From: Thiel Sydney - Capital Projects on behalf of Thiel Sydney - Capital Projects <SydneyT@ckschools.org>
To: licensing@ahbl.com; Nick Rheaume
Cc: Johnny Hong; Richard Wilson (rwilson@integrusarch.com); Mike Hager; Craig Skipton; Eatch Beck - Capital Projects
Subject: RE: Soule Drainage Pipe
Date: Thursday, January 10, 2019 8:48:02 PM
Attachments: image001.png

Mike and I field reviewed the Soule property to the north of the tennis courts. We observed a 4' drain pipe from the property outletting onto the school district property. It is most likely the roof drainage. This pipe was not identified in the design survey. The survey contours and spot elevations do not pick up the elevation at the low spot in the Soule property back yard near their fence. It is lower than 180.

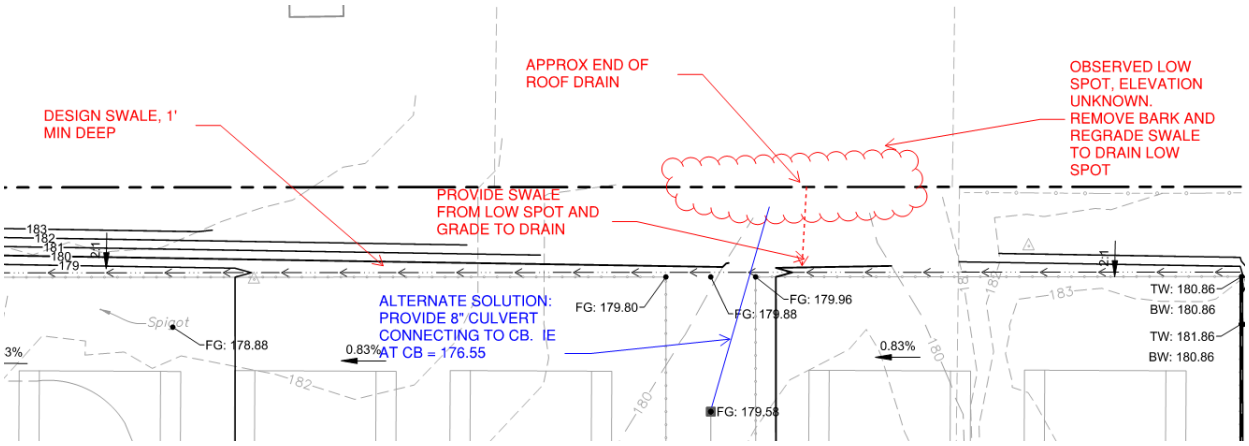
The design intent shown on the drawings is to provide a swale along the north edge of the tennis courts. The V-ditch should be a minimum of 1 foot deep and slope to the west, eventually outletting into the ditch along Frontier. I see two possible solutions:

Option 1. Establish the ditch as shown below in red. Removing bark and regrading is necessary to provide the ditch 1 foot deep and maintain a slope of .83% to the west. The elevation of the low spot should be obtained as well as the outlet end of the roof drain pipe to confirm this depth of swale is adequate.

Option 2. Provide a 8" culvert from the low spot at the north property line and connect to the tennis court CB. Repair HMA paving.
